Technical Service Bulletin	Group
		20 - Engine Mechanical
		Number
		99-20-004
Subject	Date	
1996-2000 1.8L AND 2.0L ELANTRA/TIBURON ENGINE PARTS CHANGES	12-1999	
	Model	
	<i>Elantra 1996-2000 and Tiburon 1997-2000</i>

1996 - 2000 1.8L and 2.0L elantra / Tiburon engine parts changes?

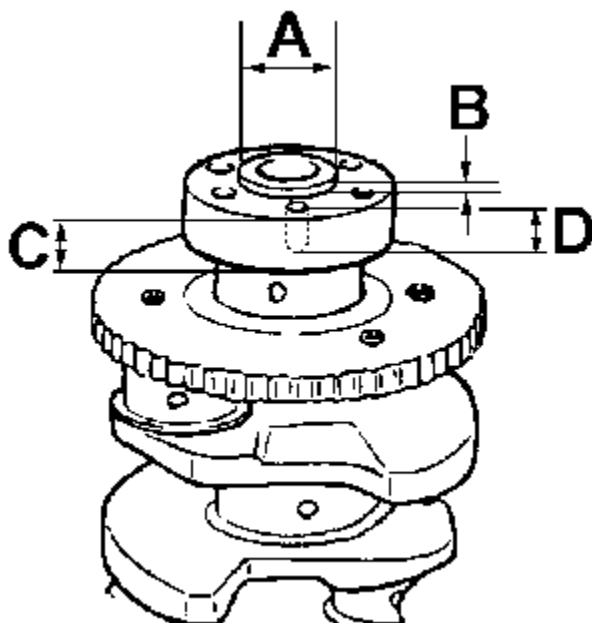
CRANKSHAFT

The new **crankshafts** (P/N 23110-23710 for the 2.0L); P/N 23110-23510 for the 1.8L) released July 8, 1999 have the following dimensional changes.

A. The flywheel mounting flange (pilot) diameter has been reduced from 41 mm to 35 mm.

B. The flywheel mounting flange (pilot) height has been increased from 4 mm to 6.5 mm.

C. The crankshaft rear flange thickness has been reduced from 20.5 mm to 18 mm.

D. The crankshaft rear flange bolt hole depth has been reduced from 15 mm (? 1.5mm) to 12.5 mm (? 1.5 mm).

The new crankshafts are **not interchangeable** with the previous ones. However, a crankshaft spacer (P/N 23112-23900) can be attached to the new crankshafts to **make them interchangeable** with the older crankshafts.

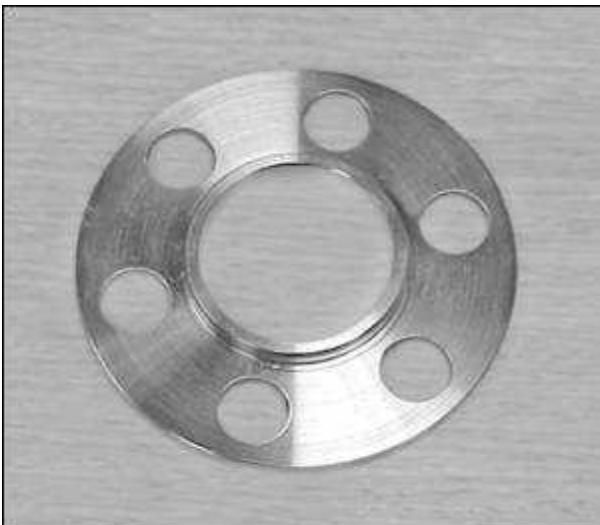
FLYWHEEL AND FLEX PLATE

The flywheel and flex plate assemblies have been changed to fit the new crankshaft. The new flywheel and flex plate assemblies **are not backward compatible** with the older crankshaft. However, the older flywheel and flex plate can be **made interchangeable** by mounting a crankshaft spacer (P/N 23112-23900) onto the new style crankshaft.

A. The flywheel and flex plate assembly pilot bore diameter has been reduced from 41 mm to 35 mm.

B. The flywheel pilot bore depth has been increased from 5.0 mm to 7.5 mm. Dimension B is recessed.

**Crankshaft Spacer
P/N 23112-23900**
